Project	<b>IEEE 802.16 Broadband Wireless Access Working Group</b> < <a href="http://ieee802.org/16">http://ieee802.org/16</a> >	
Title	<b>Change Request of the 16m modulation for the IEEE 802.16m SDD</b>	
Date Submitted	<b>2009-03-10</b>	
Source(s)	Dr. Wu Zhanji Beijing University of Posts and Telecommunications (BUPT)	<a href="mailto:wuzhanji@bupt.edu.cn">wuzhanji@bupt.edu.cn</a> <a href="mailto:wuzhanji@163.com">wuzhanji@163.com</a>
	Luo Zhendong, Du Ying CATR	{luozhendong, duying}@mail.ritt.com.cn
	Du Yinggang Huawei Technologies	<a href="mailto:duyinggang@huawei.com">duyinggang@huawei.com</a>
Re:	Change Request to 802.16m SDD (802.16m-08/003r7) - Target topic: "11.13.1.5 Modulation".	
Abstract	We propose that coding-rotated-modulation OFDM should be supported.	
Purpose	For 802.16m discussion and adoption	
Notice	<i>This document does not represent the agreed views of the IEEE 802.16 Working Group or any of its subgroups. It represents only the views of the participants listed in the "Source(s)" field above. It is offered as a basis for discussion. It is not binding on the contributor(s), who reserve(s) the right to add, amend or withdraw material contained herein.</i>

# Chang

Fig. 1 Coding-rotated-modulation OFDM scheme

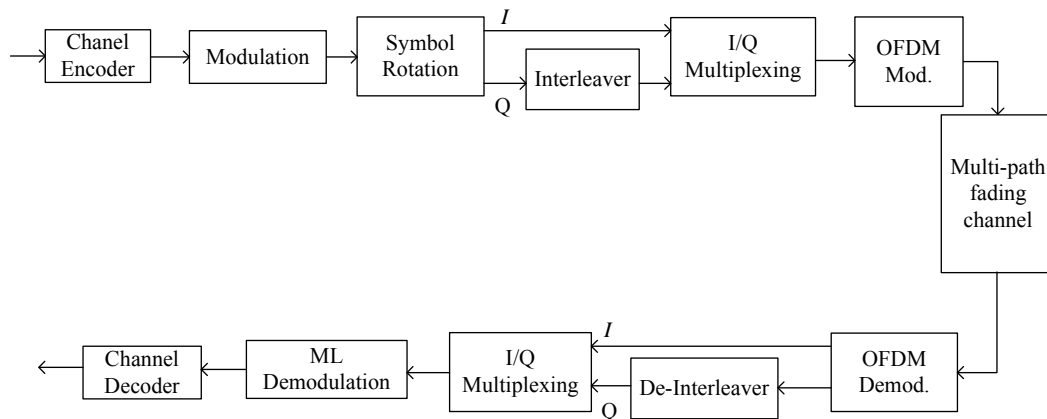
Coding-rotated-modulation OFDM scheme should be supported, as shown in Fig. x.
